Environmental Assessment Report
with Response-to-Comment

Comments from Environmental Protection Department, dated 5 January 2026

Section 12A Rezoning Application for Proposed Columbarium on Various Lots in D.D. 41, Sha Tau Kok, New Territories

Environmental Assessment Report

Figure 4.2

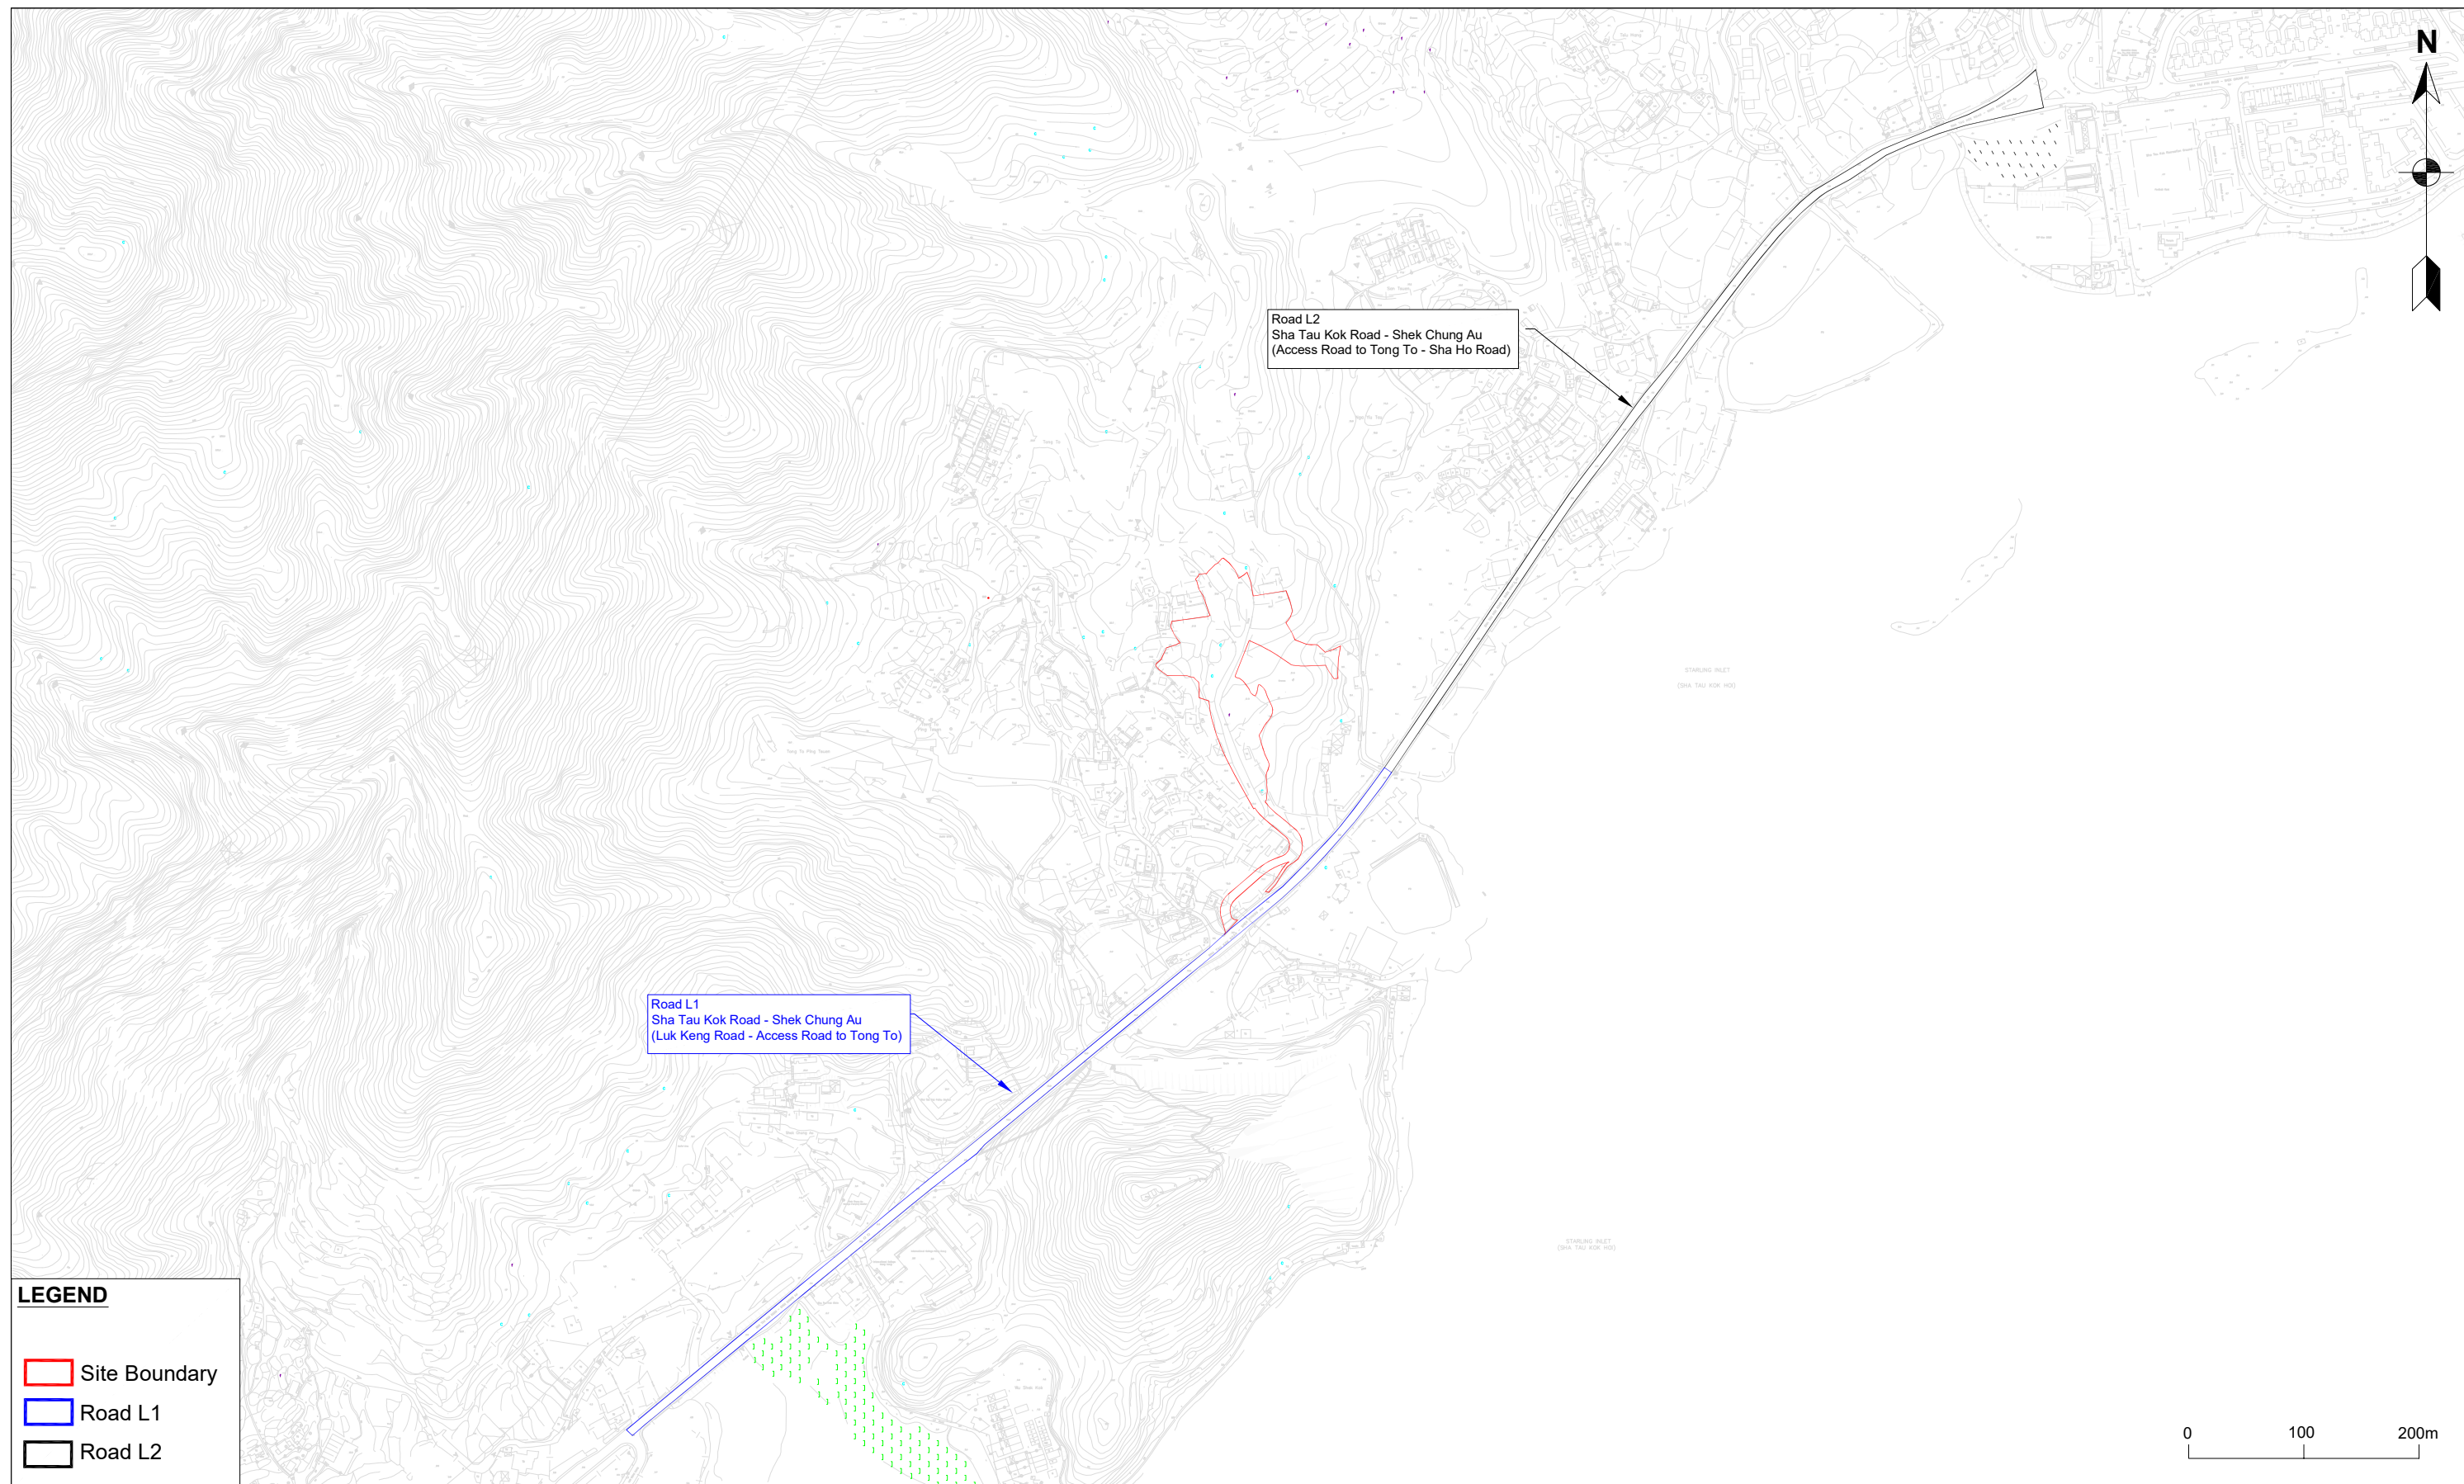
Items	Comments	Response
Comments on Environmental Assessment Report from EPD		
1	<u>Air Quality</u> Sections 3.6 and 3.7: Please delete the last sentence in the 1st paragraph in Section 3.7. Please provide an assessment of the cumulative air quality impact associated with the concurrent projects. If the projects are of limited scale and are sufficiently separated from the proposed site, please document this in the Report.	Noted and revised. Please refer to Section 3.7.
2	<u>Noise</u> Section 4.5.1: Please provide written proof of TD's endorsement on the traffic forecast data in Year 2045.	Please refer to Appendix C. TD has no comments regarding the traffic forecast data, but they have other comments in other aspects.
3	Appendix D: According to Table 4.2, there are 12 NSRs. However, only 2 points (Road L1 and L2) are assessed, without indicating the location. Please specify the locations of assessment location in a map for Table 4.5 and Appendix D. Also, please assess the impact for each representative NSR.	- According to EIAO Guidance Note No. 12/2023, Clause 4.7.7, calculation of road traffic noise level has been conducted. The results showed that there will not be significant contribution to the cumulative road traffic and would not cause the overall road traffic noise level to increase by 1.0 dB(A) or more. Please refer to the attached spreadsheet for the calculation and the location of the concerning roads is provided in Figure 4.2.
